TENDER 18-14

BIG ROCK BOAT RAMP RECONSTRUCTION

ADDENDUM NO. 3

May 14th, 2018

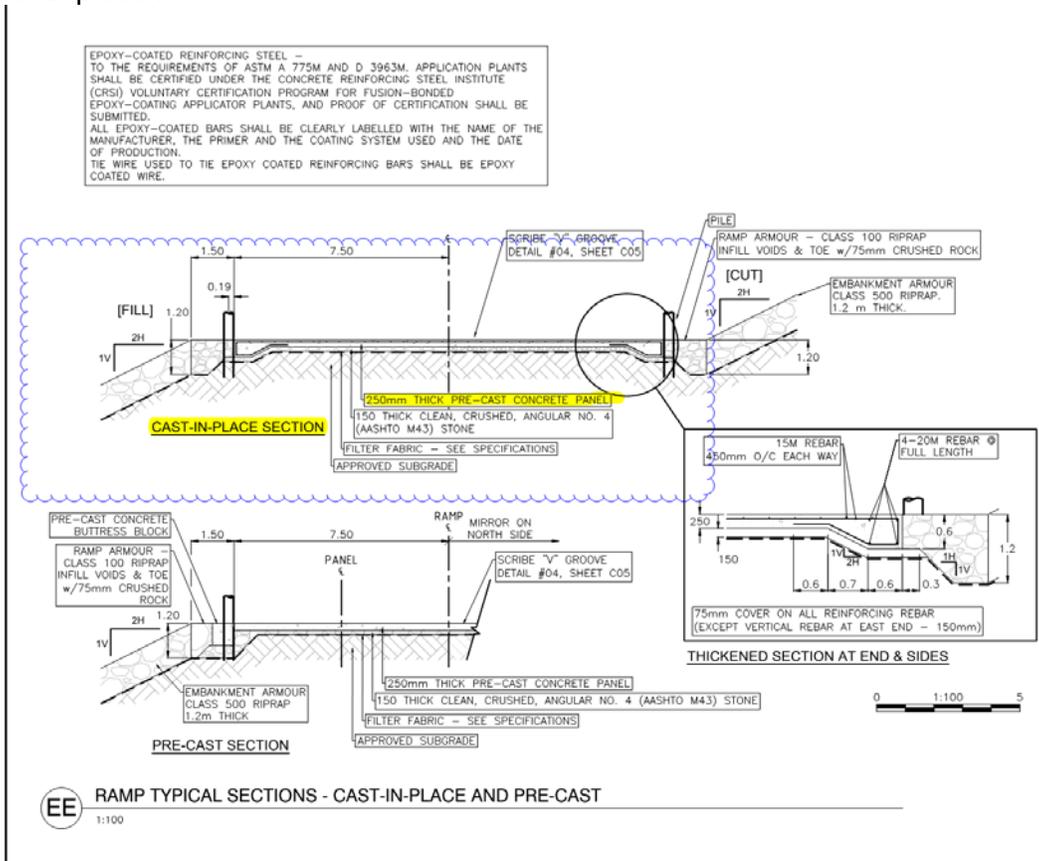
In regards to the 250 thick pre-cast panel highlighted in yellow. Please confirm that this should read "cast in place".

This note should read “250mm thick cast-in-place concrete ramp”
